ADDENDUM NUMBER 1

DATE OF ADDENDUM: May 9, 2016

**BARKER HIGHWALL MAINTENANCE
TUSCARAWAS COUNTY, OHIO
ODNR PROJECT NUMBER TS-Go-58**

SCALE:
SCALE: 1" = 20'

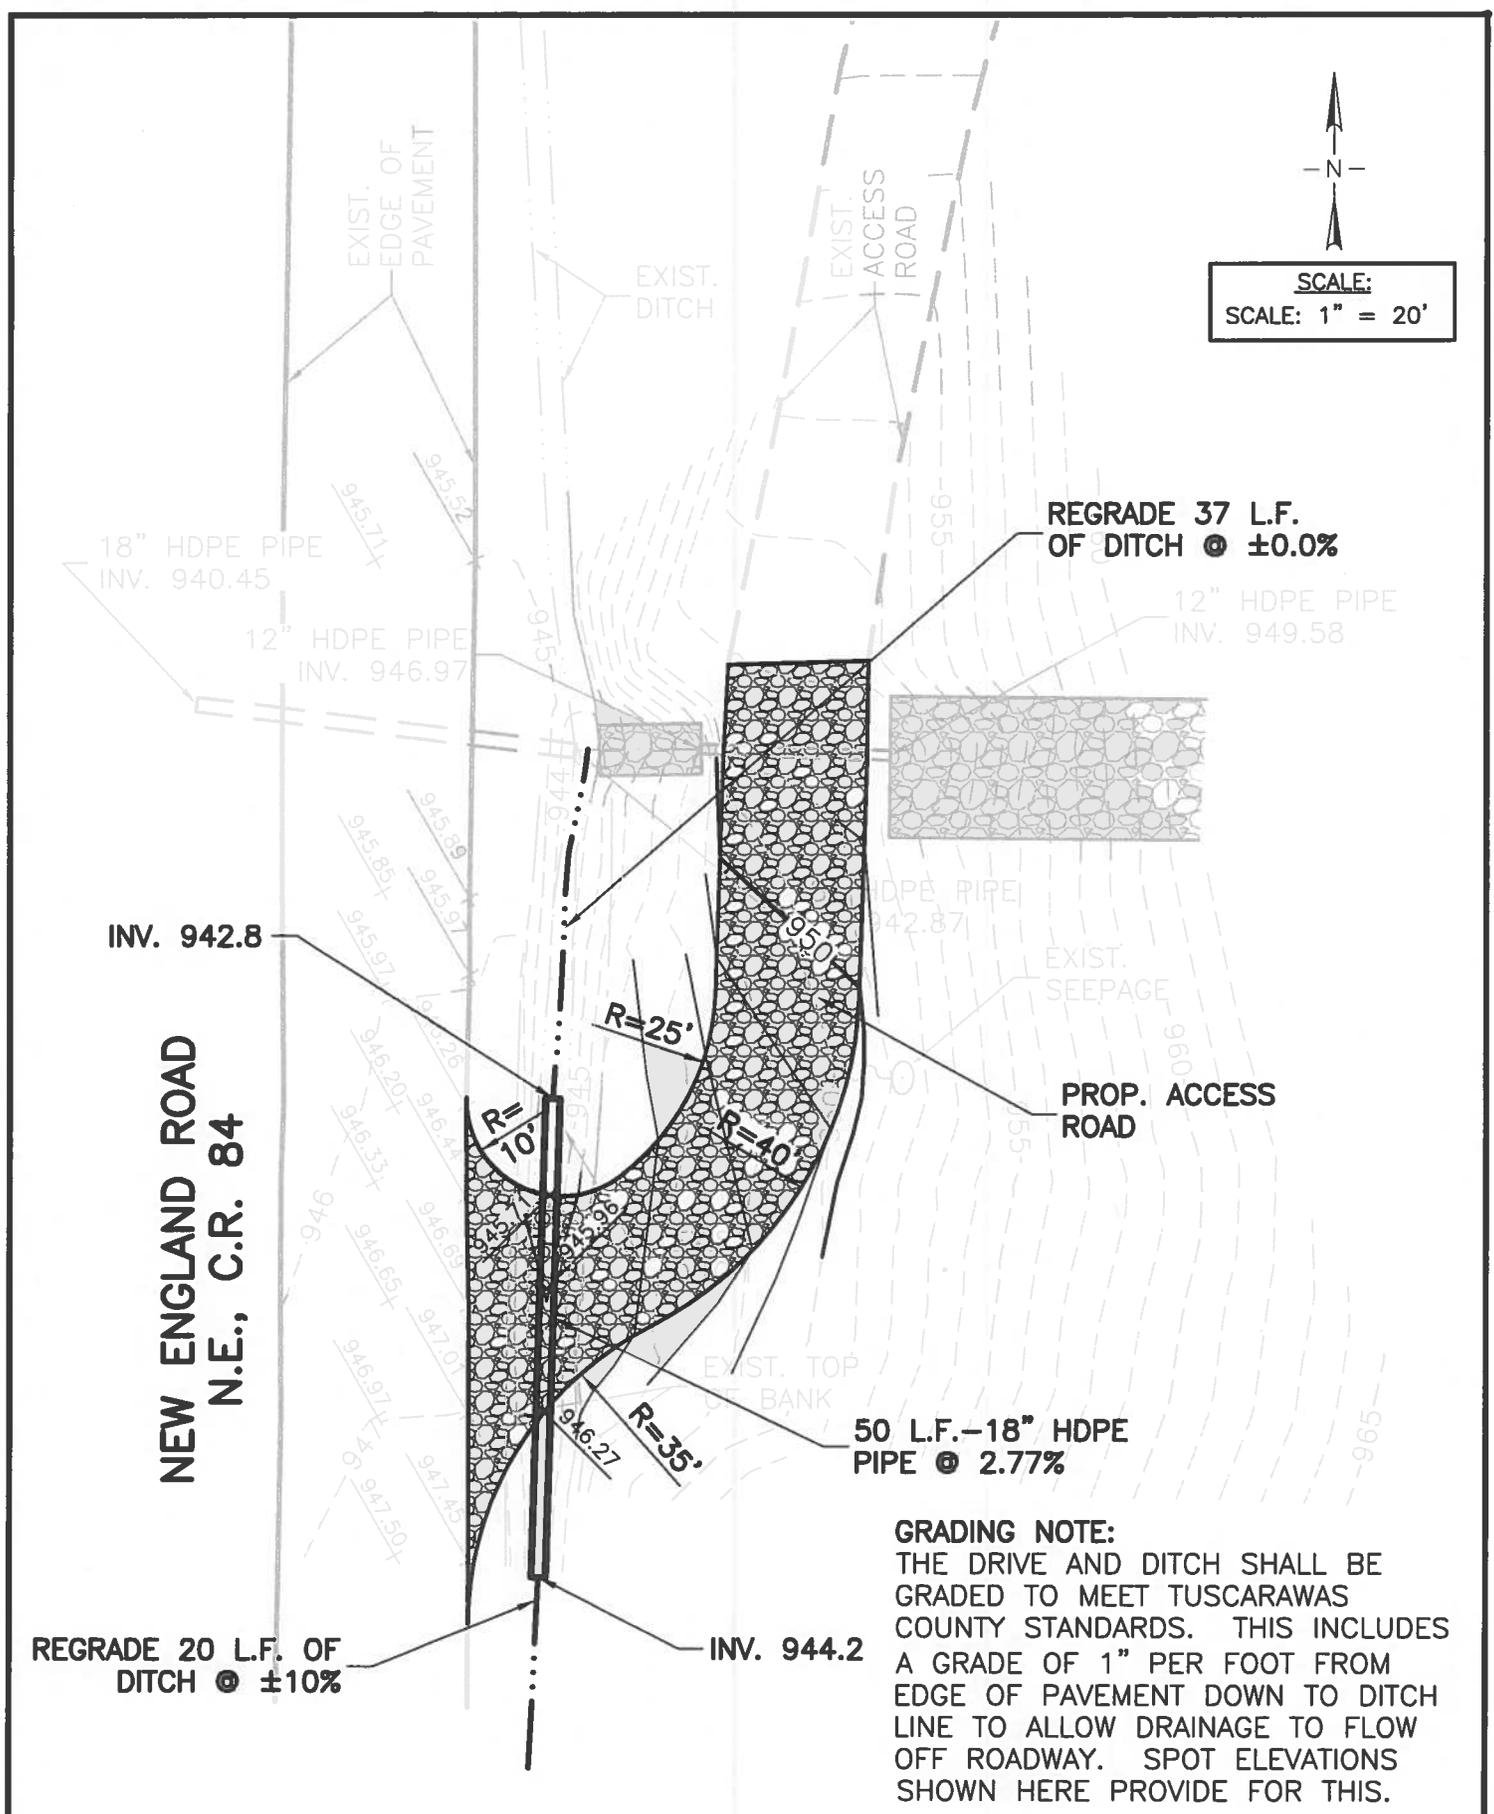
- A. Description. This item shall include all material, labor, and equipment necessary for the installation of a drive entrance to the project area along the east side of New England Road as indicated on the Addendum No. 1 Exhibit. This item will include any grading required as shown on exhibit to adhere to Tuscarawas County Engineer standards as well as ditch grading to provide positive drainage.

The bedding material, backfill material and access stone shall be placed according to the Addendum No. 1 Exhibit. In addition, grading of entrance and road ditch shall be according to Tuscarawas County Engineer standards and Addendum No. 1 Exhibit.

GRADING NOTE:
THE DRIVE AND DITCH SHALL BE GRADED TO MEET TUSCARAWAS COUNTY STANDARDS. THIS INCLUDES A GRADE OF 1" PER FOOT FROM EDGE OF PAVEMENT DOWN TO DITCH LINE TO ALLOW DRAINAGE TO FLOW OFF ROADWAY. SPOT ELEVATIONS SHOWN HERE PROVIDE FOR THIS.

18-INCH DIA. HDPE ACCESS ROAD CULVERT
NOT TO SCALE

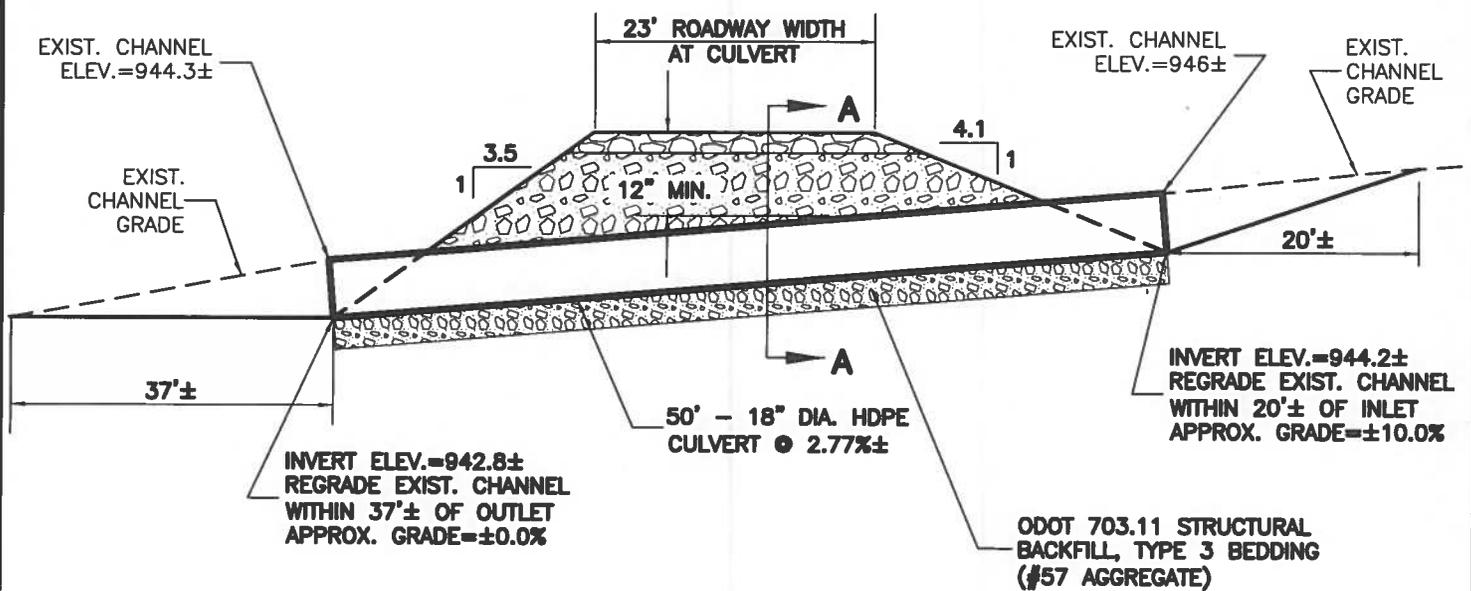
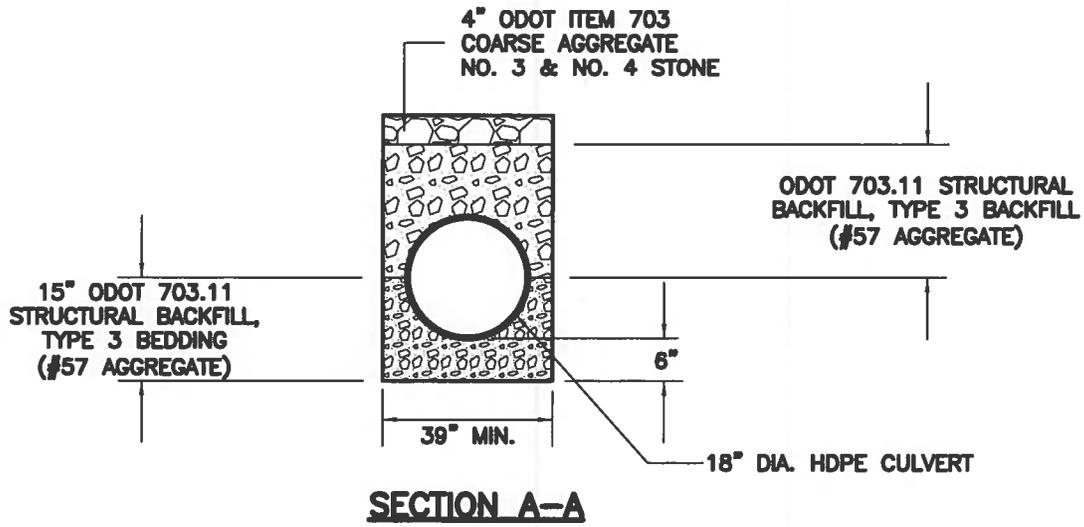
- C. Installation. The pipe shall be installed according to the details on the Addendum No. 1 Exhibit. The pipe and fittings shall be connected and installed in accordance with manufacturer's instructions.

THIS CULVERT IS A PERMANENT STRUCTURE AND SHALL REMAIN AT THE END OF THE PROJECT.

THE CULVERT MAY BE ABLE TO BE INSTALLED IN THE EXISTING ROAD DITCH. HOWEVER, DITCH GRADING AND FIELD CONDITIONS MAY REQUIRE CULVERT LOCATION TO BE MOVED TO THE EAST FROM CURRENT DITCH CENTERLINE.

POSITIVE DRAINAGE TO THE CULVERT AND ROAD DITCH SHALL BE OBTAINED.
